## **Addendum No. 2 To Proposal**

### **P25-02 New Construction of a Fire Hall, Fire #4, in the community of Alliston, ON**

**February 07, 2025**

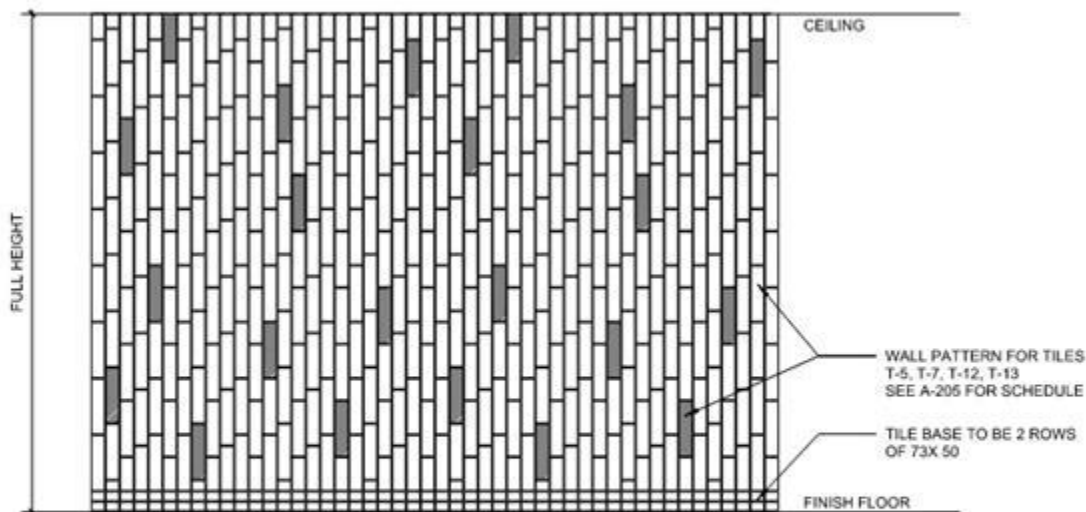
Detail #2 on pg. A-210 mentions T4 Tile: Centura Ardoise Plombe Matte as tile base for Corridor 128 where T1, Floor Tile is mentioned?

Spec mentioned above doesn't match with T-4 spec provided on pg. A-205?

Room finish schedule calls for T-1, Tile Base to match adjacent flooring (T-1, Floor Tile)

For Clarity: Detail #2 on drawing A-210 should be a T1 tile as per drawing A-205 to match the T1 adjacent floor tiles in room nos. 100, 109, 115, 120, 127 & 128.

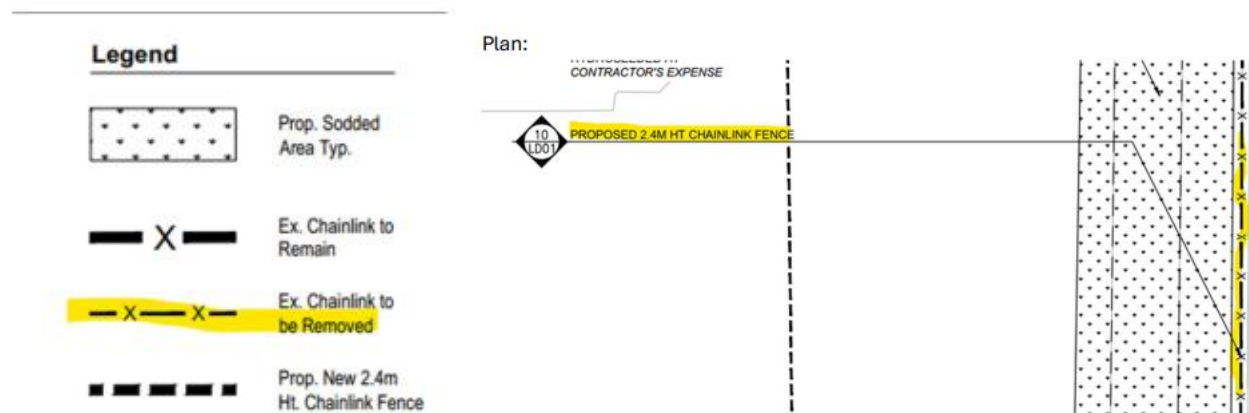
Regarding question 51 in Addendum # 1, is the security contractor responsible for the back boxes, string and conduits for wifi, data, security etc? or are the conduits and back boxes the electrical contractor’s responsibility and the security and data contractor are just responsible for the wires?

The conduits and back boxes are the General Contractor / subcontractor's responsibility and the security and data contractor are just responsible for the wires.
